**CITY OF SAINT PAUL
HERITAGE PRESERVATION COMMISSION STAFF REPORT**

FILE NAME: 248 Seventh Street East – B & M Furniture Building

DATE OF REPORT: February 7, 2017

Sheet Number: A2.01

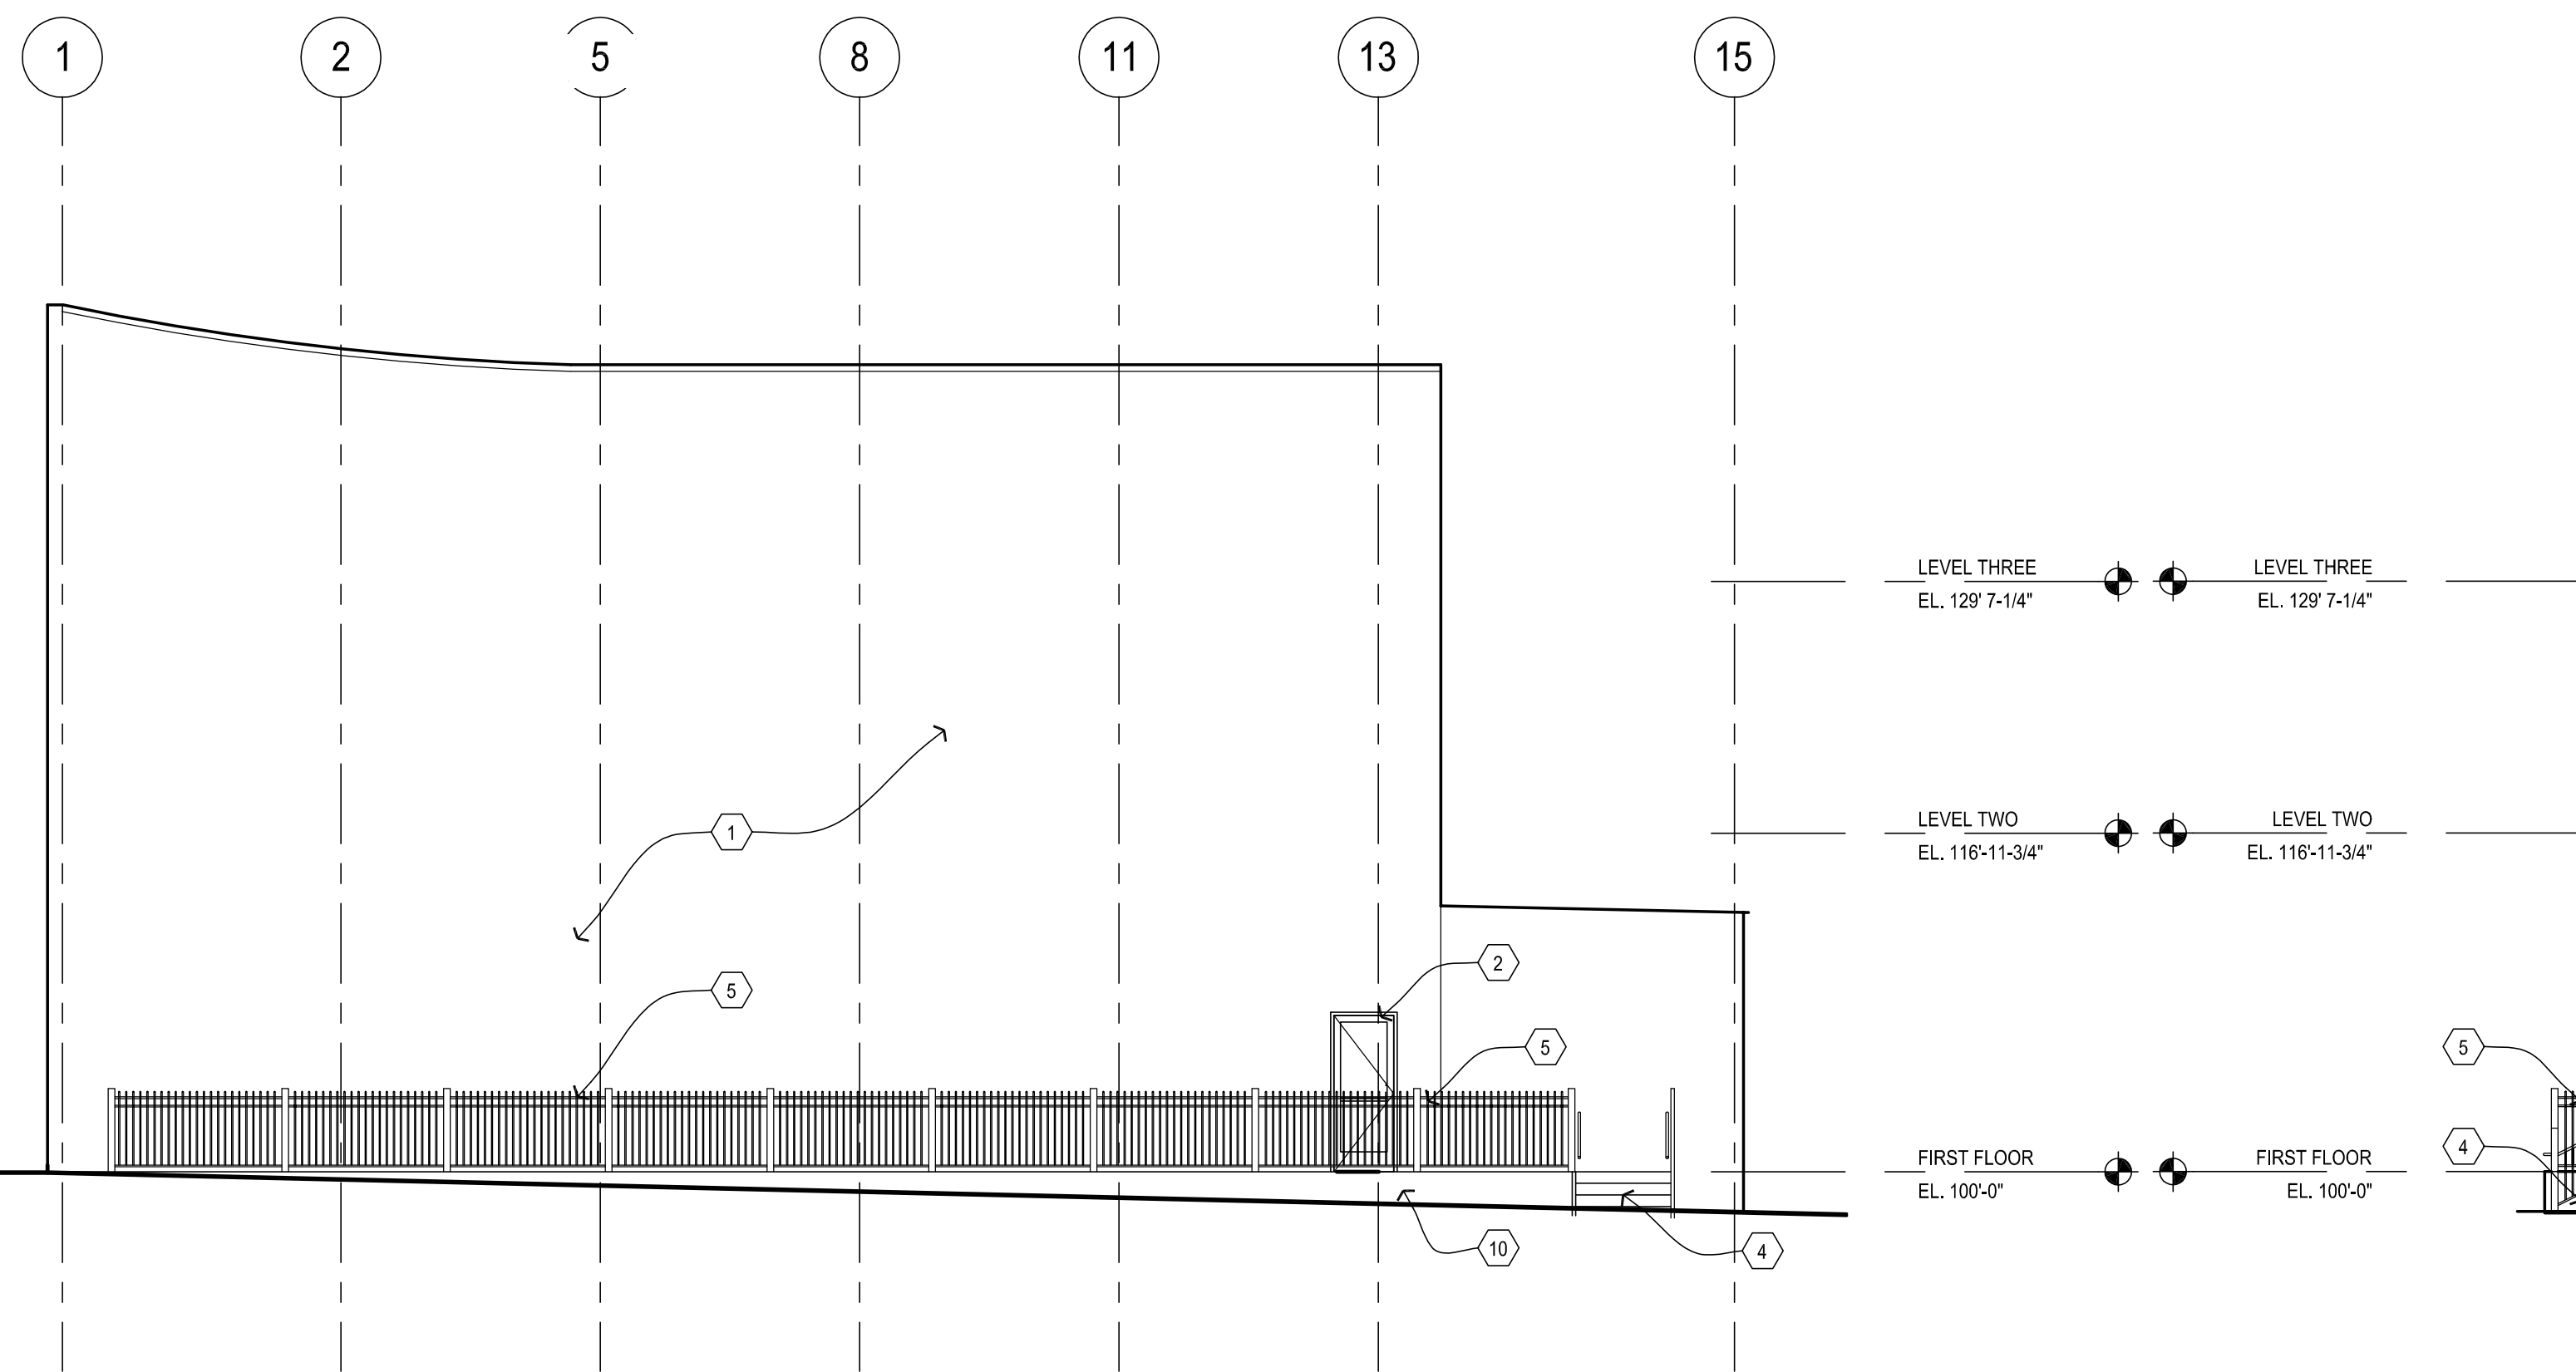
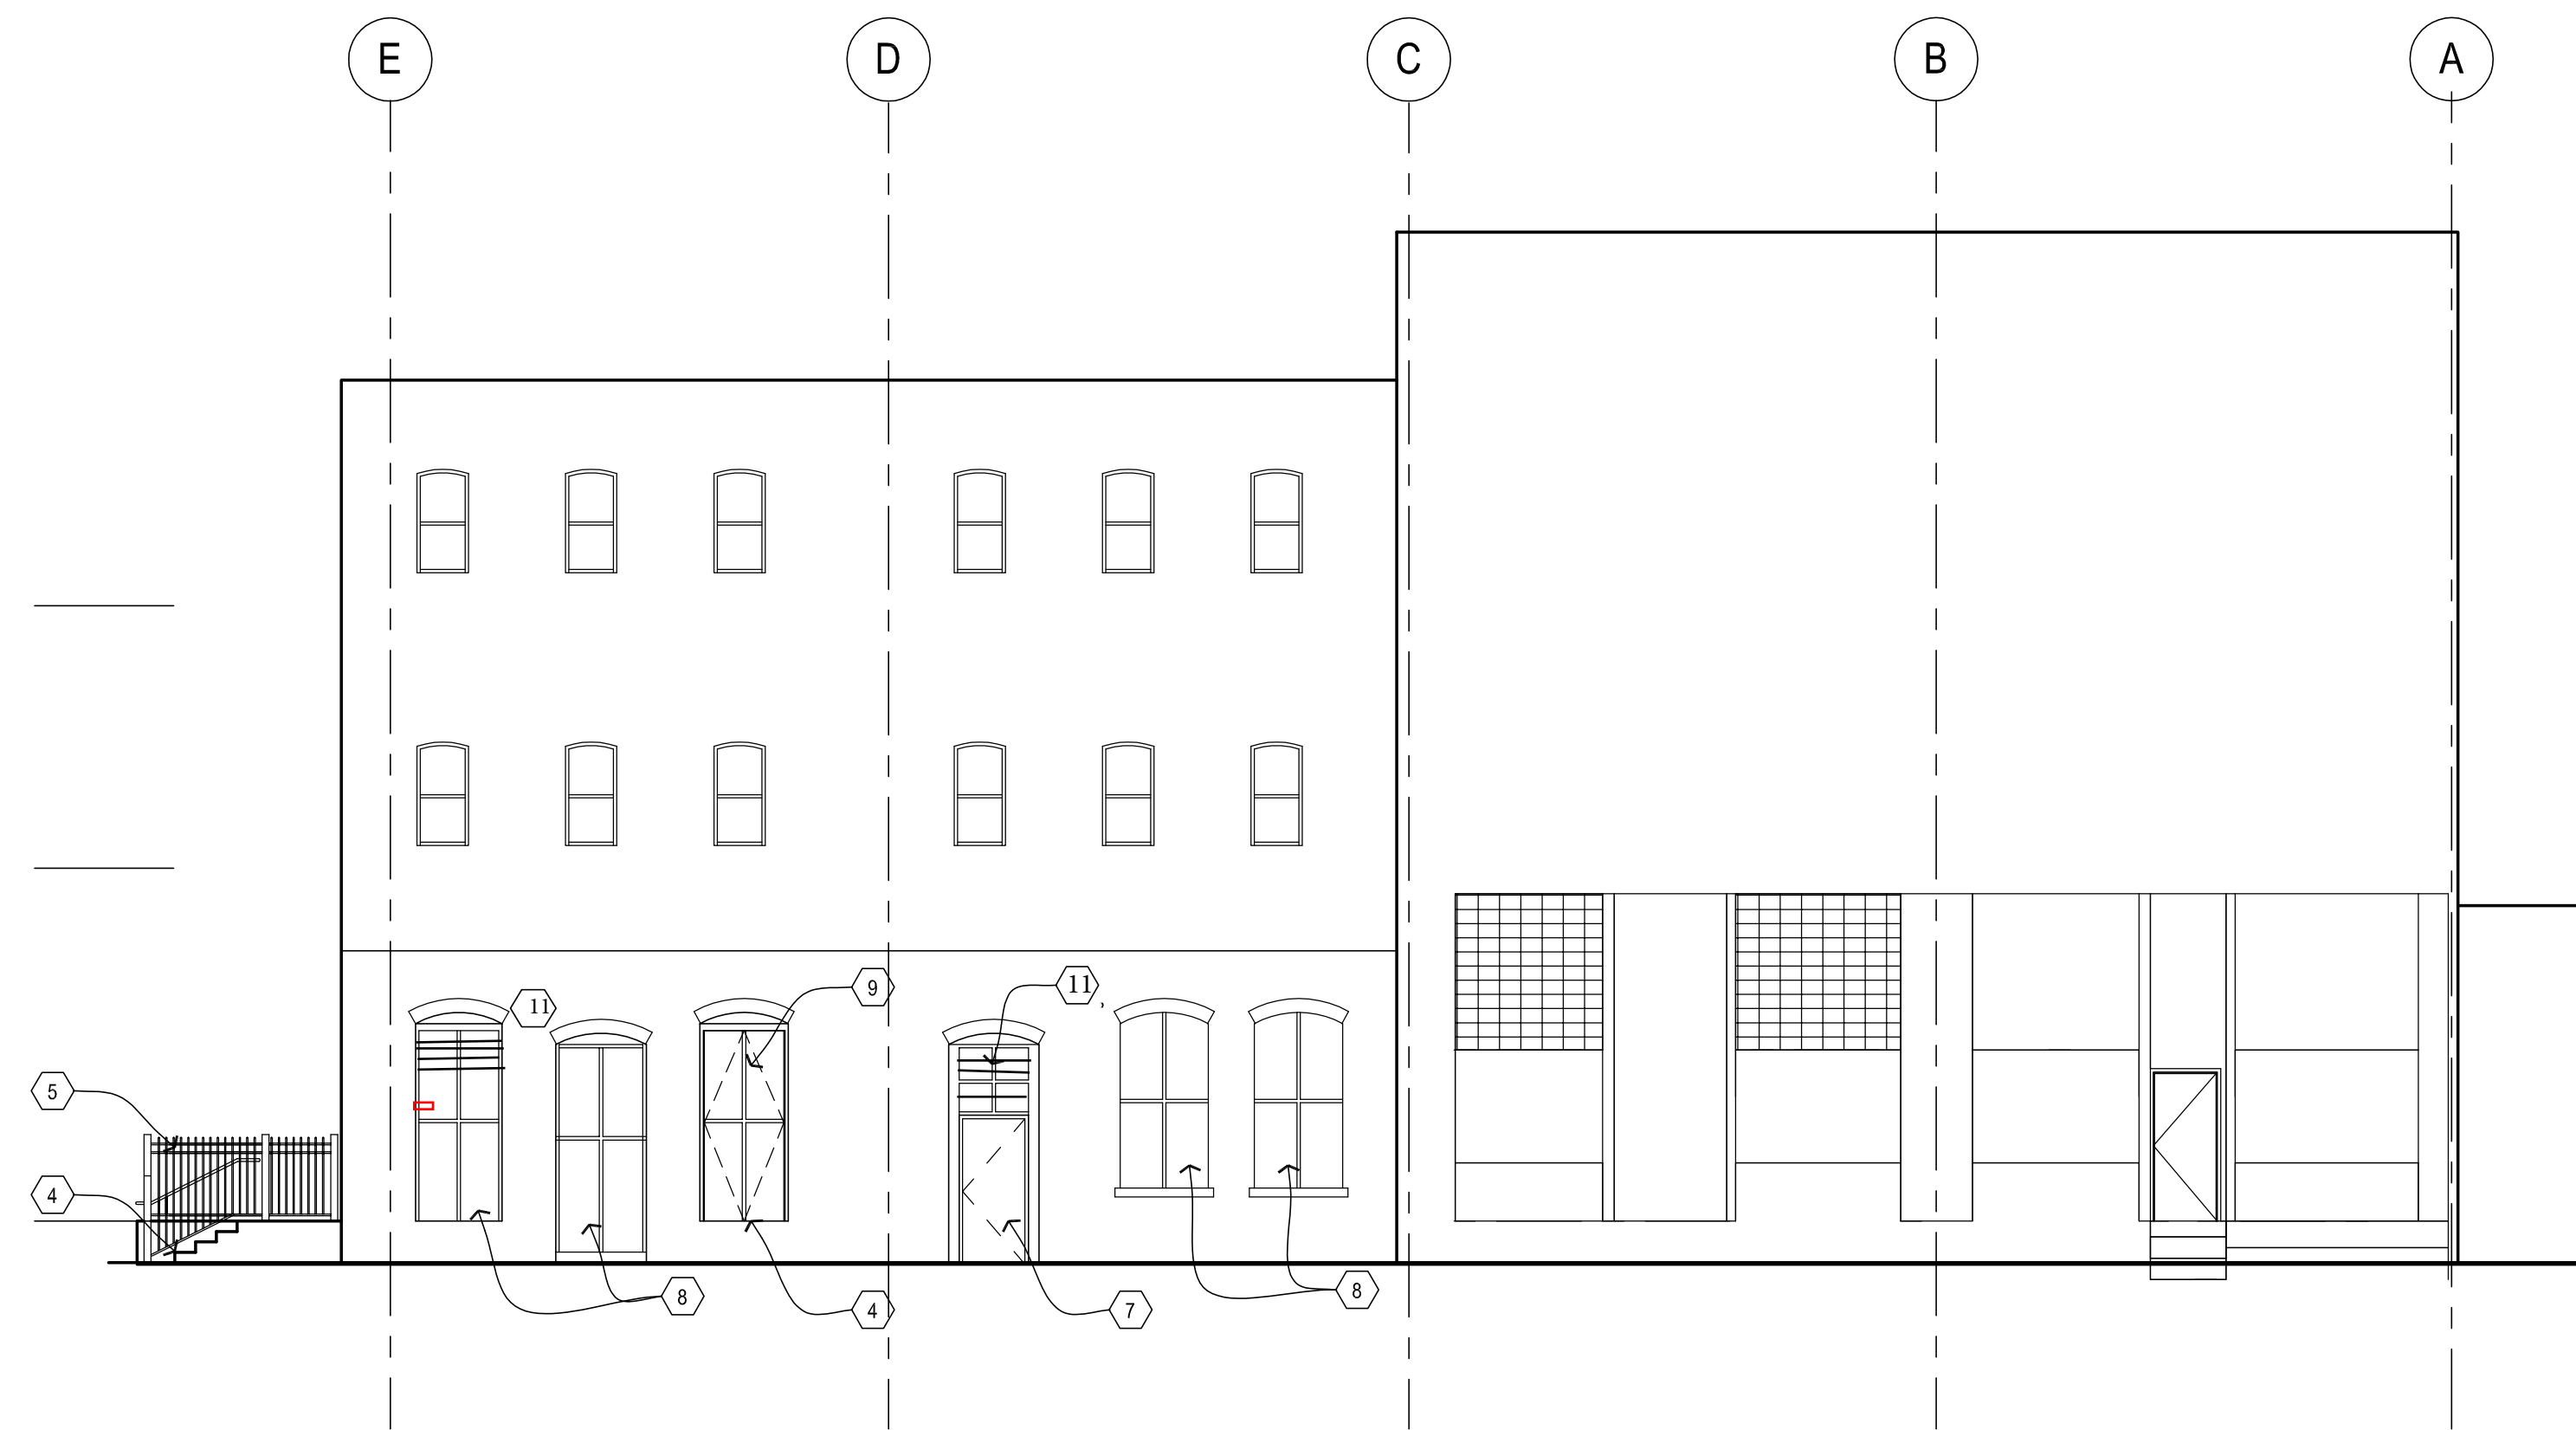
- b. New opening - The limestone rubble wall on the west elevation is a primary façade, which was originally a party wall with a non-extant building to the west. The removal of a 3 ft. by 8 ft. section for the installation of a door near the southwest corner will not have an adverse impact on the property.

- c. New Patio and Fence – The concrete retaining wall, patio, and fence on the west elevation will not result in the concealing or removal of architectural features or details. The patio should be installed in a way that will have as little impact as possible to the limestone wall. The metal picket fence is of a scale and character appropriate to the site and district.

5. **Storefronts §74-112.II.B.a** The openings on the alley elevation will be retained and will not be reduced or enlarged. Staff has not conducted a site visit to determine if any original windows or doors remain. If they do, they should be repaired and at minimum, kept in place for future repair.

6. **Storefronts §74-112.II.B.f** The entrances on the primary elevations were last replaced in 2006 with review and approval by the HPC. The alteration of the storefront will removal of an early or original entry way, but will not result in the loss of historic material but will result in an alteration of the configuration. Historic photographs of the storefront were not found. The tile appears to date to the period of significance and should be retained in place or used to repair any broken or missing tiles in the two other tiled entries at the façade.

7. **Vents Leg. Code § 74-112 II E** Vents are proposed on the rear elevation and in existing openings. This complies with the guideline. Specifications will need to be provided for final approval.

1. HPC staff shall conduct a site visit to photo document the storefront and alley elevations. The opening on the alley elevation shall be photographed from both the interior and exterior.
2. The shutters on the alley elevation shall be recessed into the openings with the exception of the opening with the roll-up door – the shutter shall be set into the opening as far as it can be.
3. Specifications for the vents shall be submitted to HPC staff for final review and approval. The vents shall have a dark finish and be recess in the opening.
